DevHU0163 Phillips 66 and VPI

Prepared for: Simon Geoghegan
Prepared by: Alan Philp
Date: 12th July 2024
Case Reference: DevHU0163
Document Reference: DevHU0163 006 TM
Reviewed/approved by: Terry Dale

This Technical Memorandum [TM 006] will set out our review of the information submitted.

Figure 1. Site location in relation to the Strategic Road Network¹

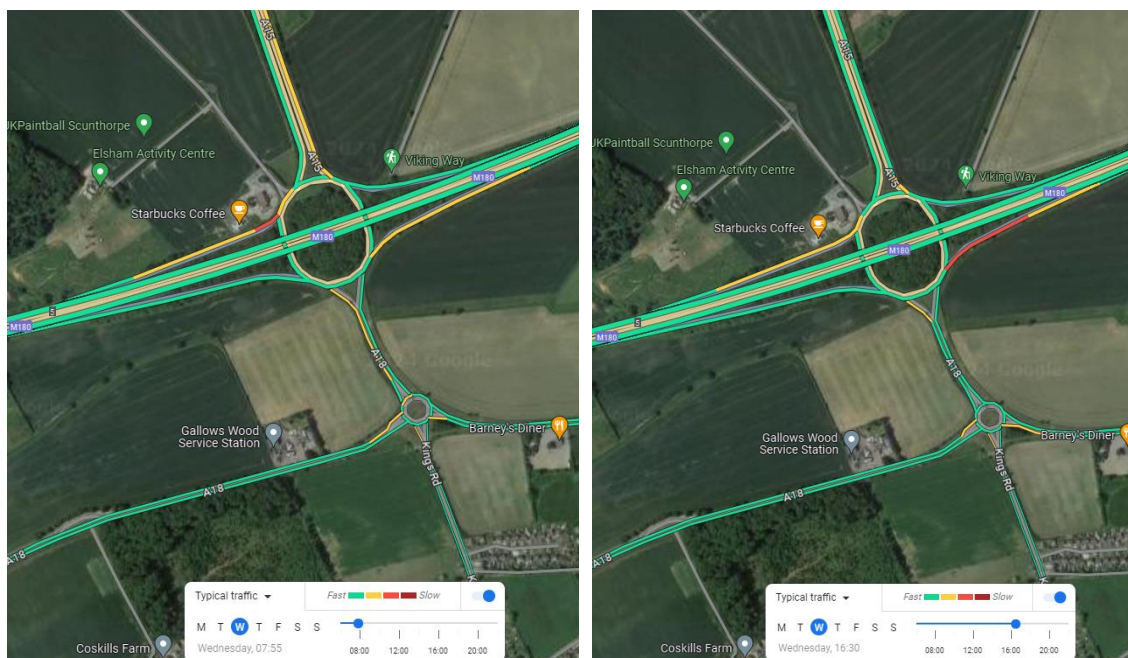
The location of the application site is presented in **Figure 1**. As indicated, the application site is situated 500m to the north of the A160 / Eastfield Road Junction. At this location, the A160 forms a section of the SRN.

Figure 4. Queues Per Lane - M180 Junction 5

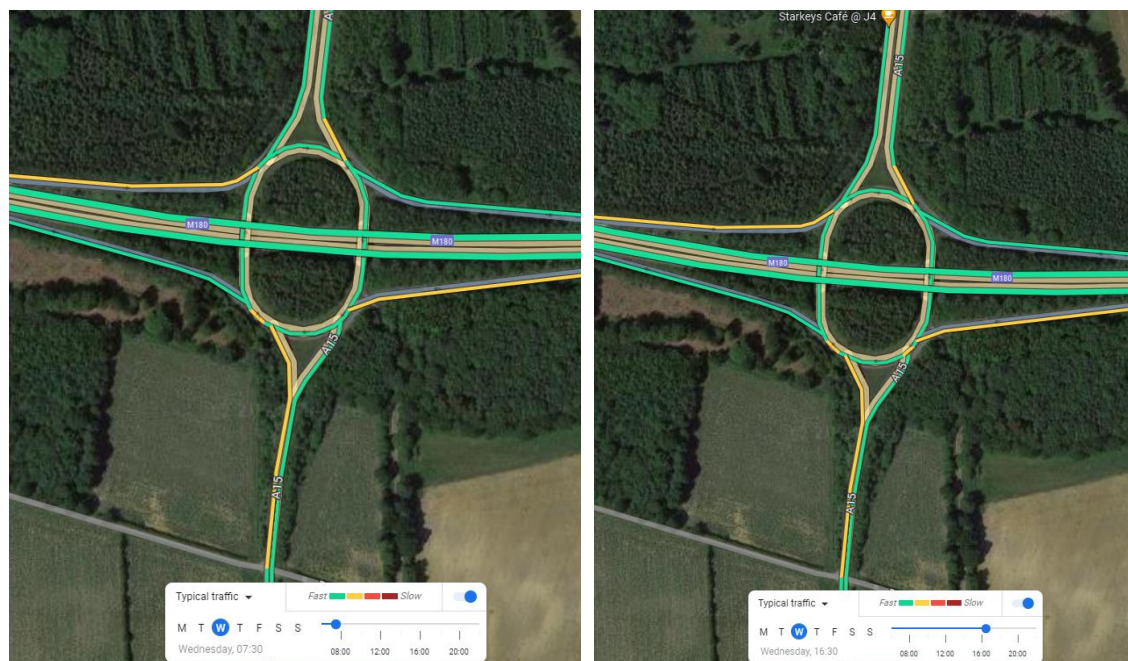
Response 5 contains assessment of the expected queue lengths on each lane of the approaches, as shown in **Figure 4**, forecast based on observed lane split. It can be seen that on the A180 off-slip the queue is forecast to increase to 56 PCU in lane 1 and 64 PCU in lane 2. The length of the two-lane section is 60 PCU therefore the forecast queue in lane 2 extends 4 vehicles into the one-lane section of the off-slip.

that the mean maximum queue [MMQ] on A180 off-slip is forecast to be 60 PCU/lane, which equates to 345m. The length of the two-lane section of the off slip is approximately 345m. We discussed the forecast operation of M180 Junction 5 at the meeting on 5th July 2024, when we noted the following:

- We acknowledged there is concern with queueing at M180 Junction 5 which is forecast to worsen as a result of the construction of the proposed development;

- We noted the BLP mitigation scheme does improve performance of the junction, however, there is no guarantee that this mitigation scheme will be in place at the time of the construction traffic impact;

- We noted that even with the BLP mitigation there is concern over the forecast MMQ at the junction; albeit we acknowledged that the development impact is during the construction phase. Hence, the impact at this junction should be addressed within the Construction Traffic Management Plan (CTMP) required as a condition of any consent; and

- The CTMP should consider issues, including but not limited to, actual on-site queueing, forward visibility to the back of the queue (as documented) and the need for mitigation measures to address safety concerns before they arise. This will likely require constant monitoring of impacts.
